# MIAMI BEACH

### Staff Report & Recommendation

### Historic Preservation Board

SUBJECT: HPB17-0150, **7409-7449 Collins Avenue & 7400-7450 Ocean Terrace.**

### **Ocean Surf Hotel – 7436 Ocean Terrace**

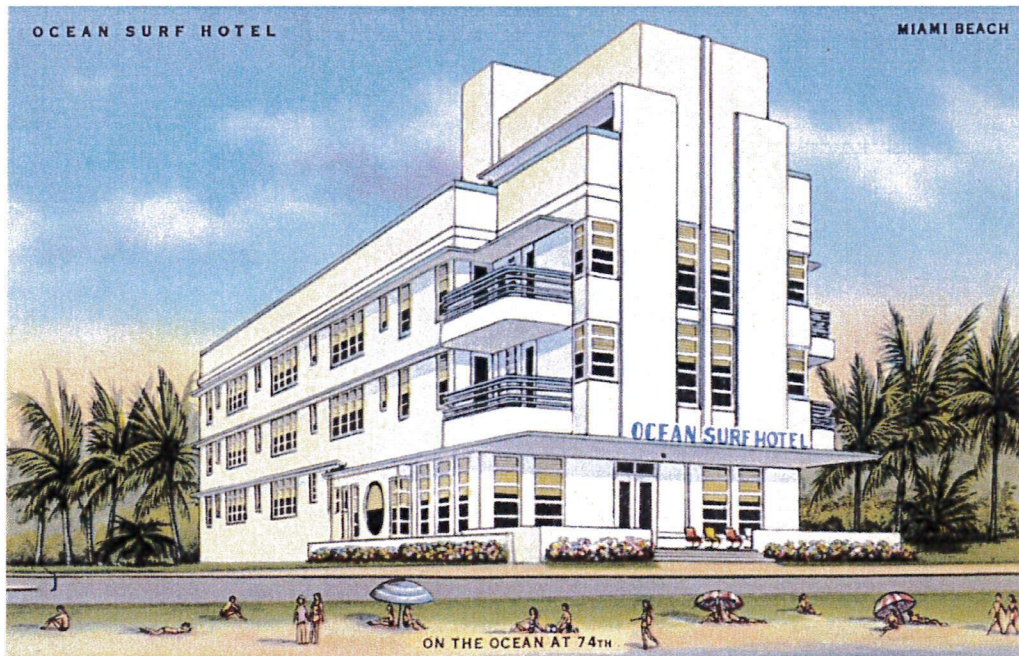
Staff would note that while the amount of demolition is extensive, all significant architectural features located on the primary façade are proposed to be retained and restored. Further, the portion of the building proposed to be demolished contains little to no significant architectural details. Staff is concerned however, with the level of demolition proposed within the original public interior spaces located at the ground level including the original lobby. The demolition plans indicate demolition of all interior features located within the ground floor with the exception of the terrazzo floor and ceiling details located within the lobby. After review of the original building permit plans, staff has determined that the existing lobby spaces are substantially intact including the original faux fireplace and reception desk. Further, staff would note that the applicant has provided extremely limited information regard to the new lobby design. The proposed plans for this area indicate only that there will be one large room with an elevator, stairs and office. At a minimum, staff would recommend that the original reception desk and faux fireplace be retained and restored. Further, staff recommends that the design of the new

Additionally, staff has a concern with regard to the modifications proposed for the penthouse portion of the building. The applicant is proposing to demolish the roof and side walls including the projecting overhangs which are horizontal extensions of the vertical banding features located on the primary façade. Staff believes that this modification will have an adverse impact on the three-dimensional quality of the building design and would strongly recommend that the entire penthouse volume be retained, restored and if desired, repurposed.
